17 PARK STREET WENDOUREE

2021052TP

Drawing Title
 17 PARK STREET WENDOUREE
 SITE VEHICLE ACCESS
 SWEEP PATH ANALYSIS

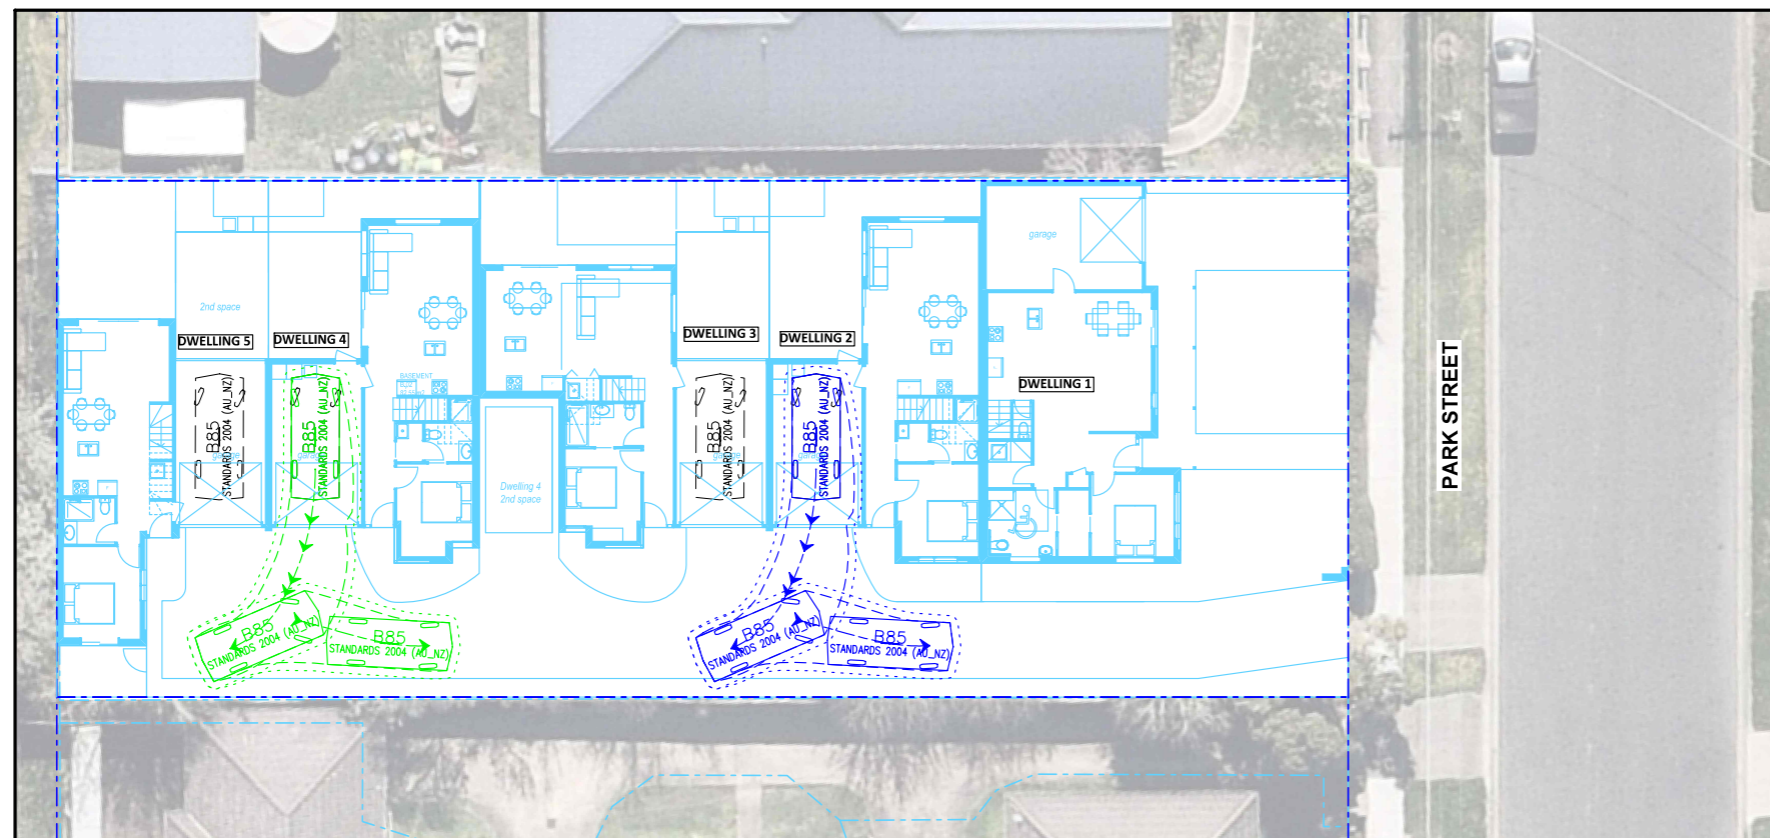
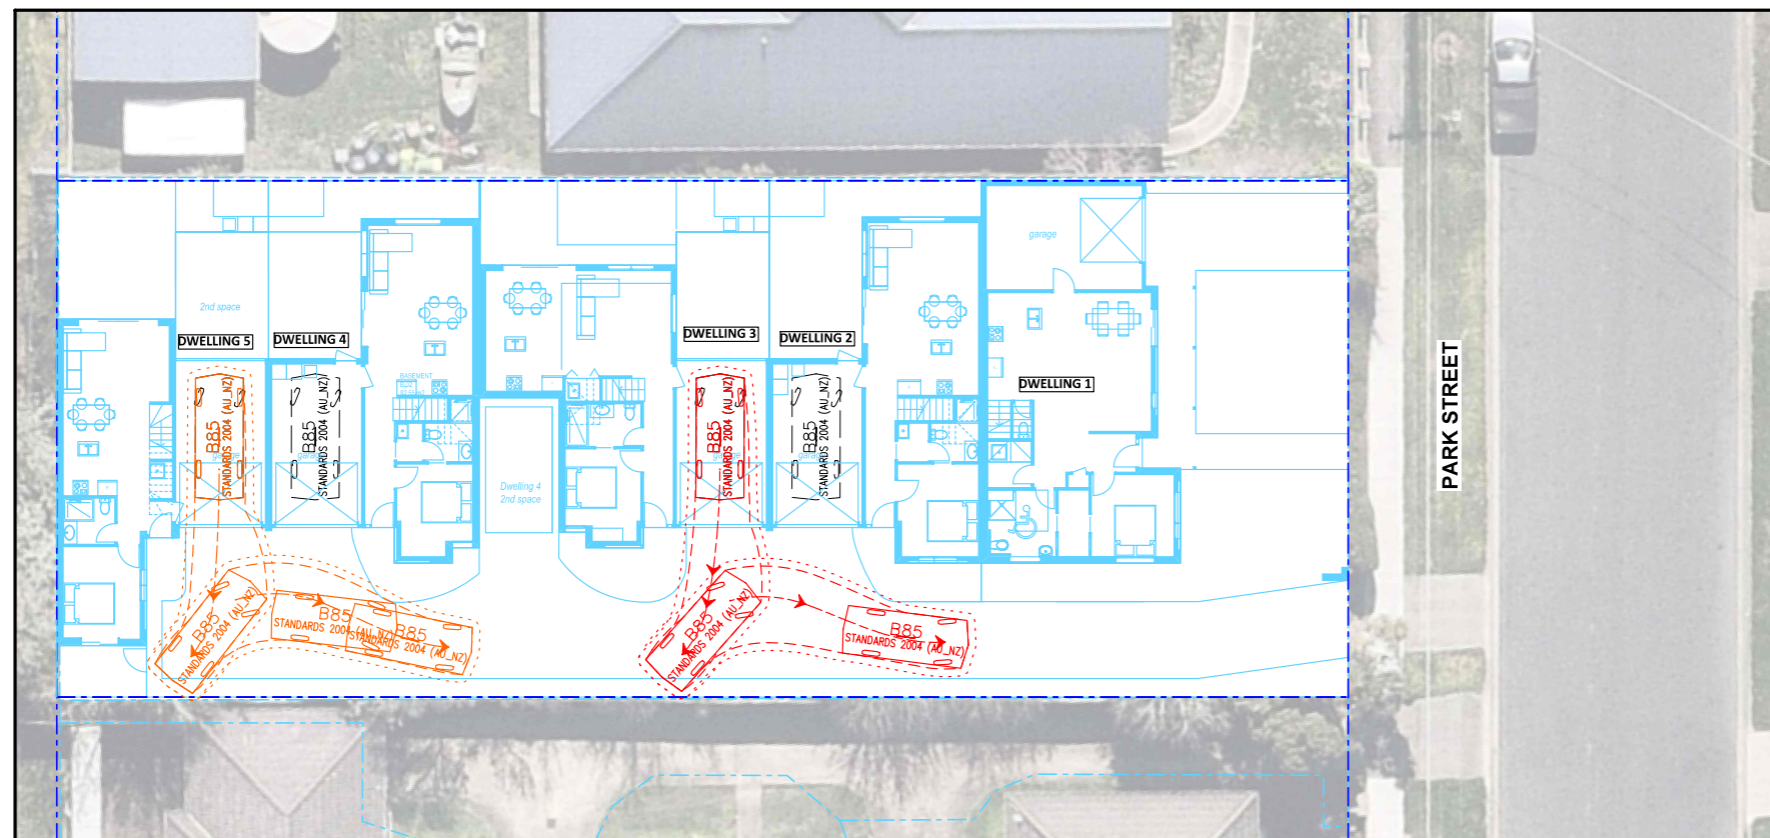
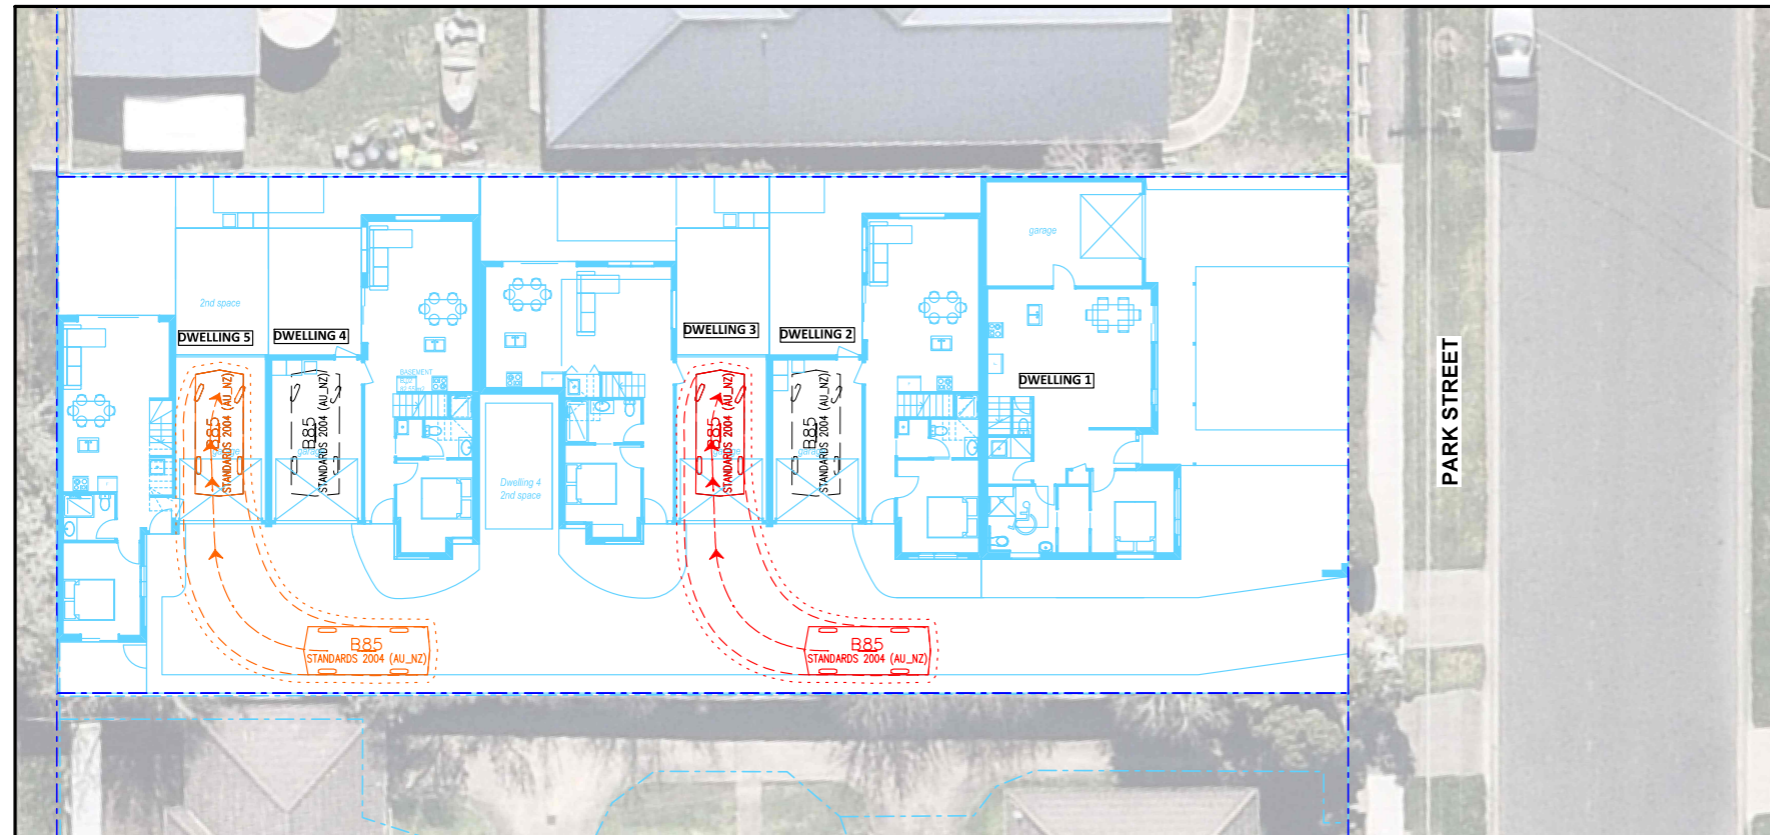
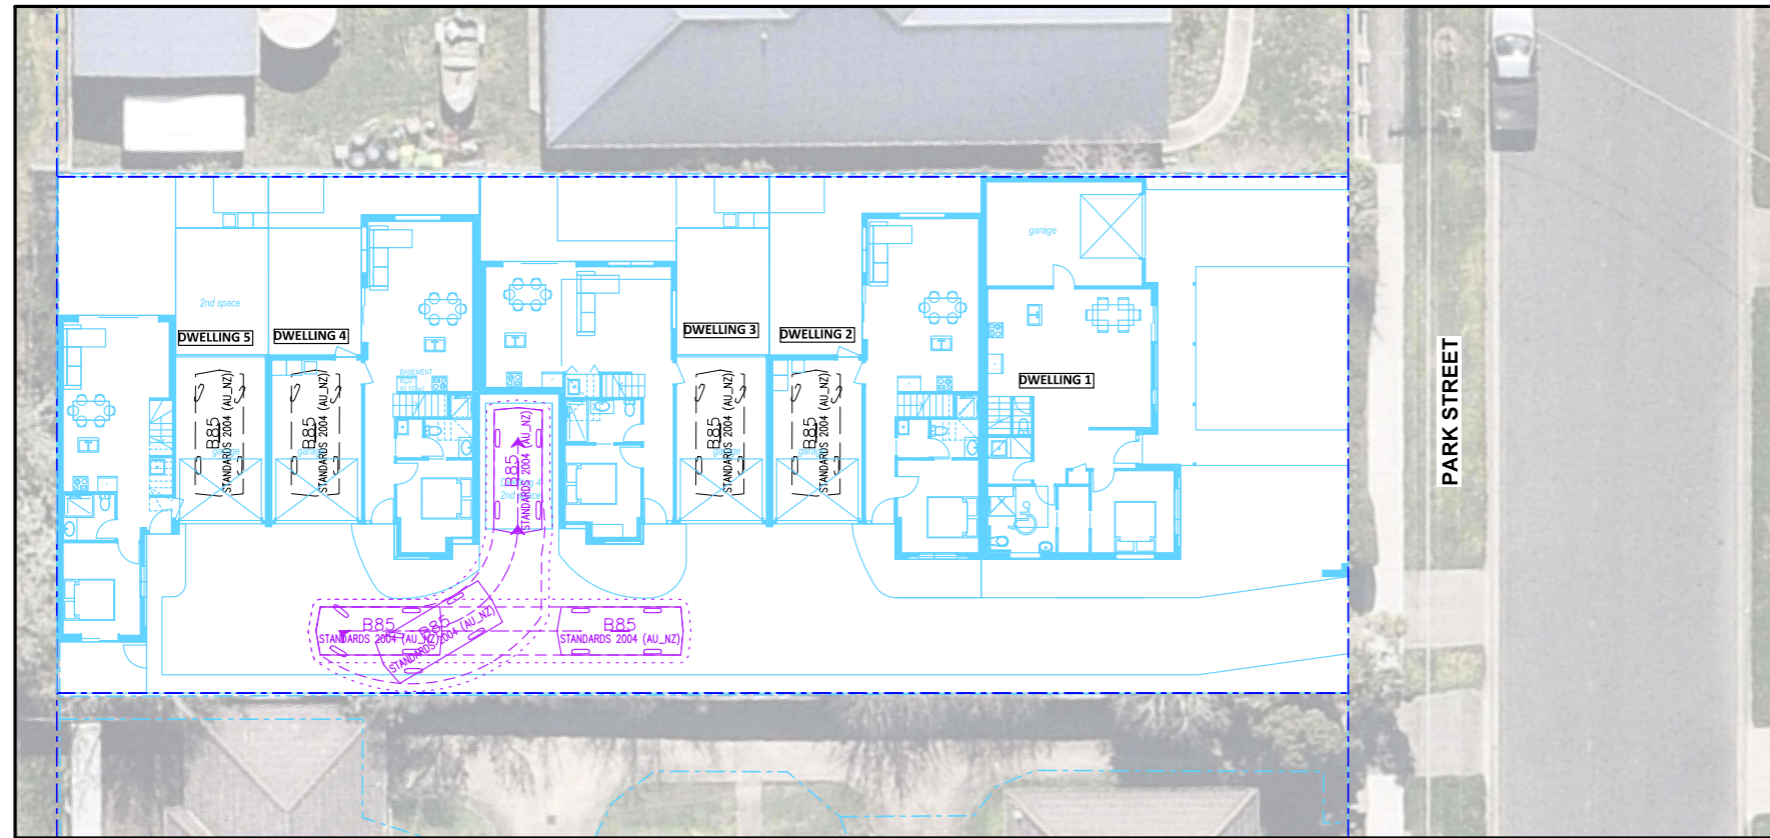
Department	Advice
Traffic & Transport	<p><i>The following is the Traffic and Transport Section's review of the proposed development of five dwellings (as amended) at 17 Park Street, Wendouree. Advice of the amended referral was received on 20 August 2021.</i></p> <p><i>The 1,012sqm site on the west side of Park Street has a 20.12m street frontage. It is occupied by a single storey brick veneer dwelling. The building is to be removed prior to development. The site is in the Residential Growth Zone and the street is a local access road under council management.</i></p> <p><i>The street frontage has a sealed road pavement, concrete kerb & channel and footpath and grassed nature strip.</i></p> <p><i>There will be five semi-detached double storey 2-bedroom dwellings running down the north side of the rectangular site with a shared accessway down the south side. The front dwelling will have 4 bedrooms and the remaining four will have 3 bedrooms each.</i></p> <p><i>There is no proposal to subdivide the dwellings at this stage.</i></p> <p><u>Layout and Property Access</u></p> <p><i>The 4-bedroom dwelling at the front of the site will have separate access from a new crossover to be constructed at the northern end of the street frontage. The remaining 3-bedroom dwellings will utilise an existing crossover and a new shared accessway.</i></p> <p><i>A revised swept path analysis has been provided for vehicles in the shared accessway. These indicate that corrective maneuvers will not be required to access all garages. All turning vehicles can undertake simple 2-point manoeuvres and enter and exit the shared accessway in a forward direction in a safe and convenient manner.</i></p>

With respect to access, it is noted that the submitted swept paths demonstrate that all vehicles can enter and exit the site in a forwards direction. Visibility splays have been shown on the plans to ensure vehicle and pedestrian safety. In terms of trip generation, the traffic impact assessment anticipates that daily vehicle trips associated with the site will range from 25 – 32.5 trips and anticipated weekday peak hour vehicle trips will range from 2.5 – 3.3 trips. Council agrees with the findings of the traffic impact report, that the traffic generated by the development would be minimal and is not expected to generate any significant adverse impacts on the local road network.

<p>4. <i>That the shared accessway, independent driveway and street crossings are constructed to council approval and drained to a legal point of discharge.</i></p> <p>5. <i>That all traffic using the shared accessway enters and exits in a forward direction.</i></p> <p>6. <i>That the Applicant makes a separate application for a crossing permit to check the compliance of the existing crossover and construct a second crossing. The arrangements and costs of all necessary works shall be borne by the Applicant.</i></p> <p>7. <i>That Waste collection services are arranged through Council's Waste Management Unit. Any service provided by Council shall be in approved bins located at the kerbside as agreed on the prescribed collection days.</i></p> <p>8. <i>That mailbox facilities are suitably located within the property line.</i></p>
Officer comment	<p>Whilst Planning Officers acknowledge the concerns raised by Traffic & Transport, having reviewed the materials submitted by the applicant, and given the site's accessible location, officers are comfortable that the traffic and parking solutions proposed are acceptable in their current form. Importantly, in a Residential Growth Zone such as this, increased scales and densities are encouraged. This is considered appropriate in a traffic and parking sense given the proximity of a variety of public transport services.</p>
